# CHANGE ORDER

PROJECT: **Loeb Stadium**  
 (Name and address) **Main Street and Wallace Street**  
**Lafayette, Indiana**

CHANGE ORDER NO.: **BP-1-5**  
 INITIATION DATE: **March 26, 2020**

PROJECT NOS.: **6617**  
 CONTRACT FOR: **BP #1 - General Trades**  
 CONTRACT DATE: **June 4, 2019**

# FOUL POLE BASE PILASTER

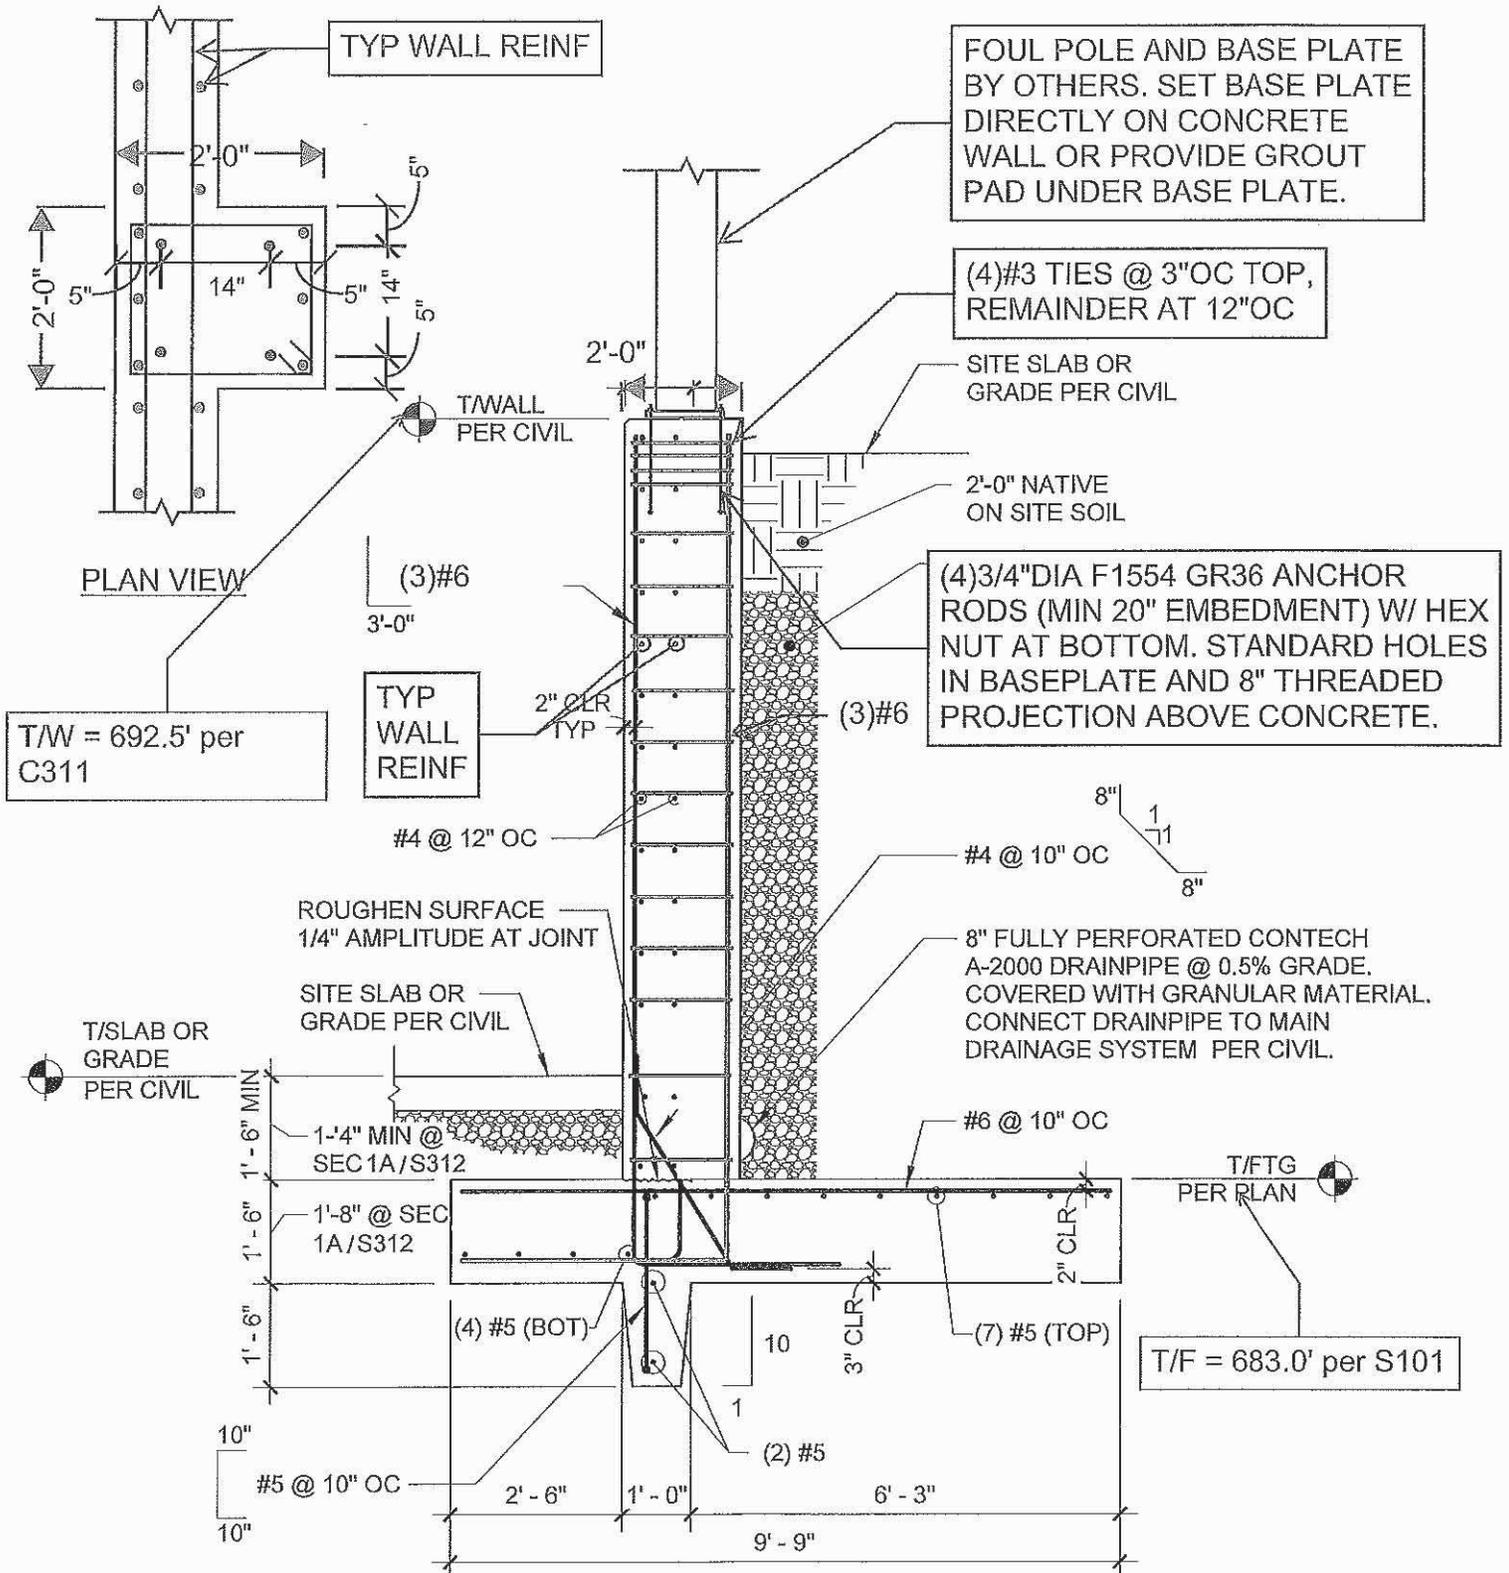
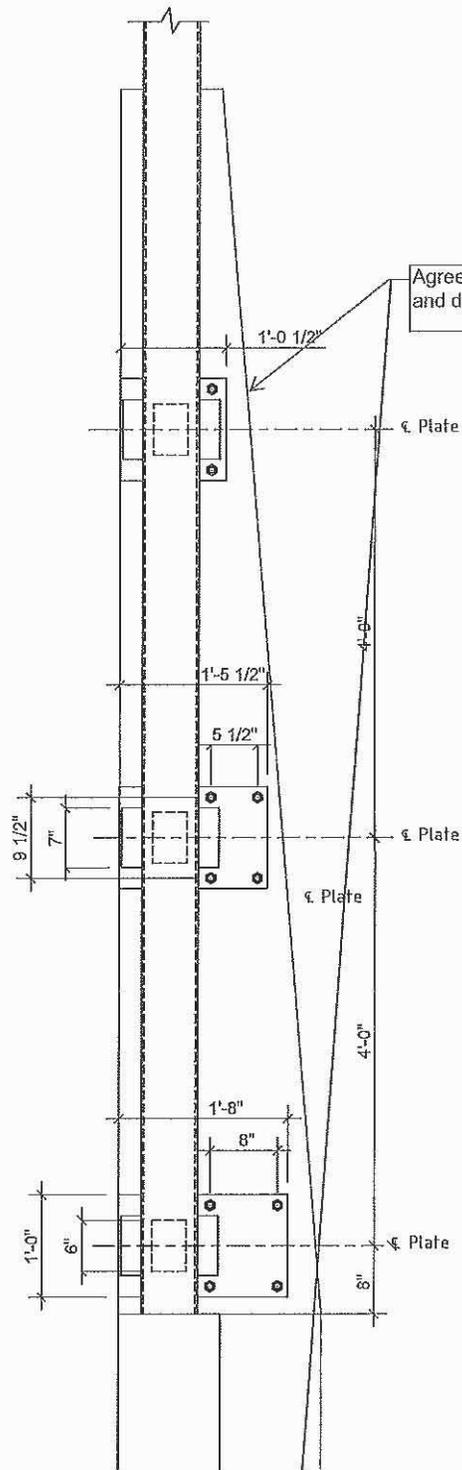
J.R. Kelly Company is pleased to provide pricing associated with the changes to the foul poles as shown in the answers to RFI #70. The RFI response changed the left field foul pole to being mounted on top of the outfield wall and the right field pole to being mounted to the side of one of the pilasters on top of the outfield wall. These changes require the addition of a pilaster to the left field wall per American Structurepoint detail SSK-001 (ASK-003) and required Sportsfield Specialties to provide custom foul poles. The cost associated with this work is:

Agreed upon custom mounting for pole and dimensions from wall pilaster
